Broadcast Products Technical Bulletin 20-2008-139

SUBJECT: PICTURE DISTORTION ON BRIGHT SCREEN

MODEL: ***BVM-D24E1WA***
BVM-D24E1WE
BVM-D24E1WEK
BVM-D24E1WU
BVM-D32E1WA
BVM-D32E1WE
BVM-D32E1WU

Figure 1

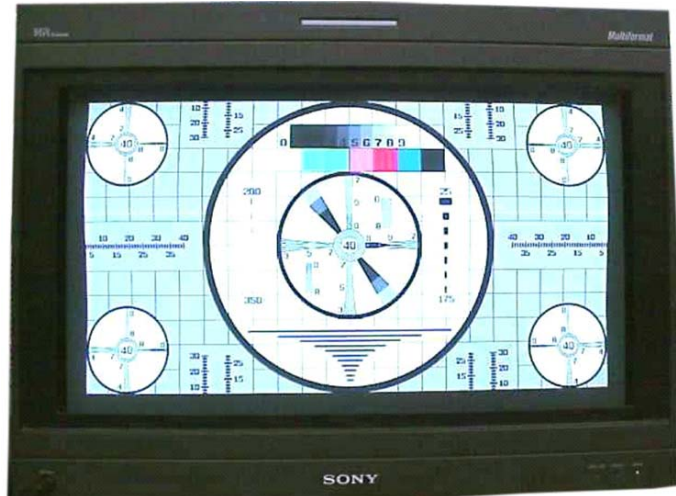
The picture may be distorted or wavy on a bright screen. The symptom is more visible when BRIGHT and CONTRAST settings are increased in under-scan mode. (See Figure 1.)

1. Replace the FBT with a new FBT.

Figure 2

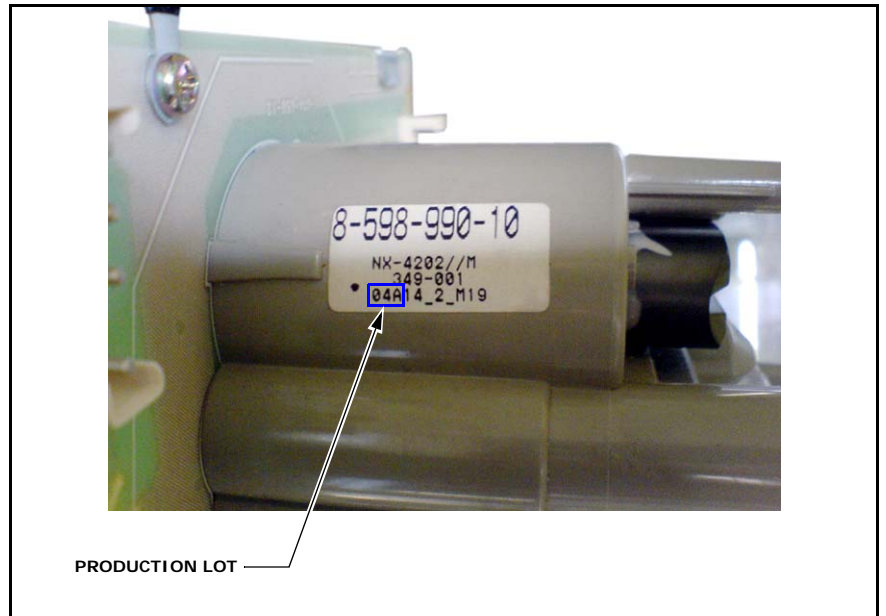
NOTE: Confirm that the replacement FBT is not from production lot 04A to 04M. (See Figure 2.)
